CAPITAL DEVELOPMENT AUTHORITY
SIMLY DAM PROJECT

Subject:- COMPARATIVE STUDY OF CONDUCTION MAIN AND
APPURTINANT STRUCTURES ON KHANPUR WATER
SUPPLY SYSTEM.

Re: REPLY TO CDA'S REQUEST AND COMMENTS.

Figure - 1 Commandable area distribution

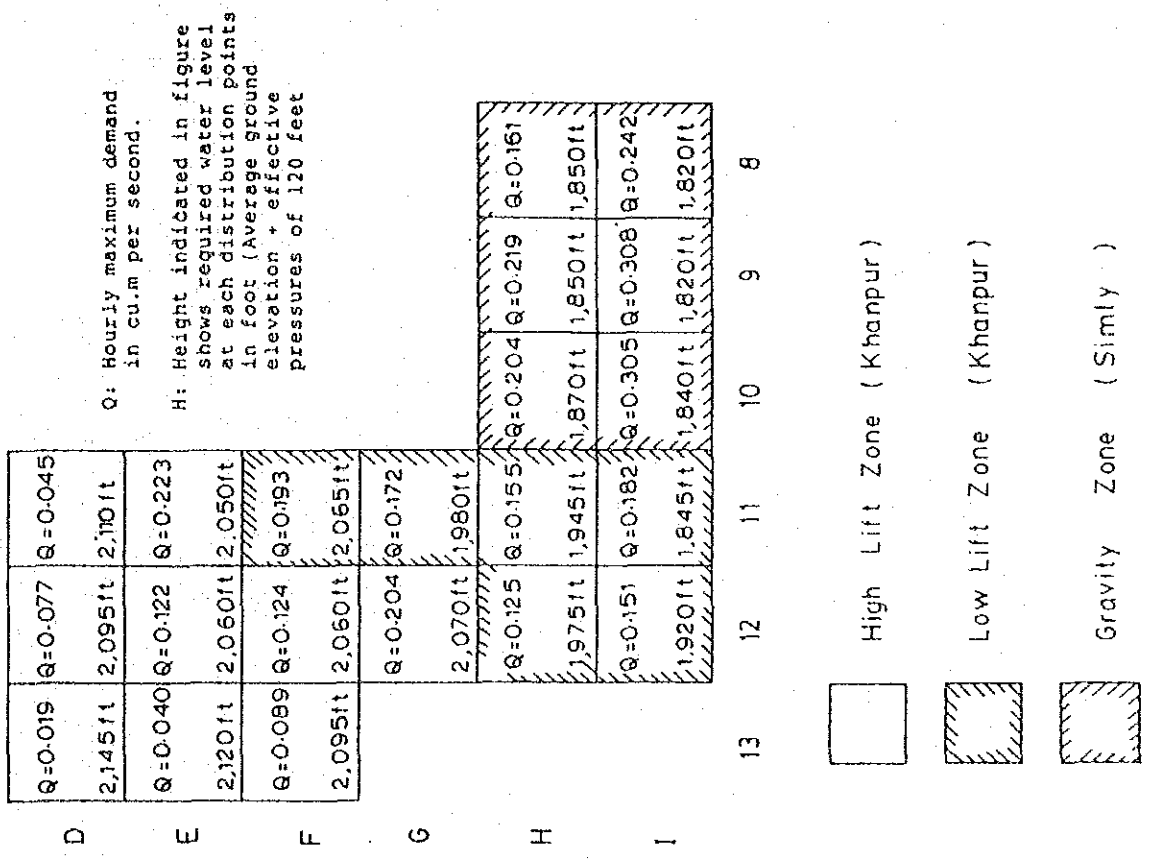
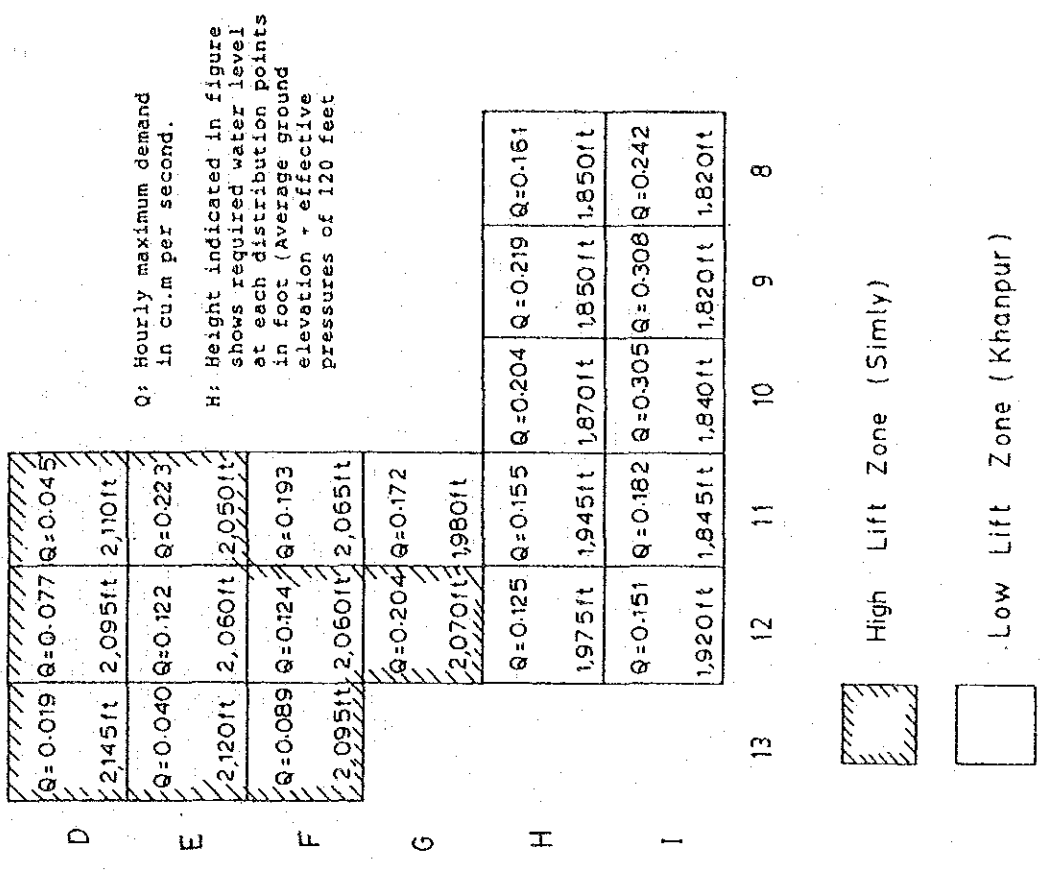
7. JICA Team may like to mark the pressure zones for Islamabad on the same lines as has been done by AESL for Rawalpindi. Most economical method of distribution of water from Simly and Rawalpindi based on these pressure zones be worked out. Simly being available at more than RL 2000 in Islamabad, it should be possible to use this water for higher zones of Islamabad with less pumping. Khanpur water may be used for lower zones where possible by gravity.

Case-A is namely series wise distribution of commandable area. The area can be roughly divided into three categories, such as high lift pump area, low lift pump area and gravity zone, which is shown in Figure-1.

The case is namely sector wise distribution of service area by the elevation of ground surface as shown in Figure-2.

The results of comparison on the construction and operation and maintenance cost show that case-A is more feasible than that of Case-B. Therefore, the plan proposed by the Team is suitable plan.
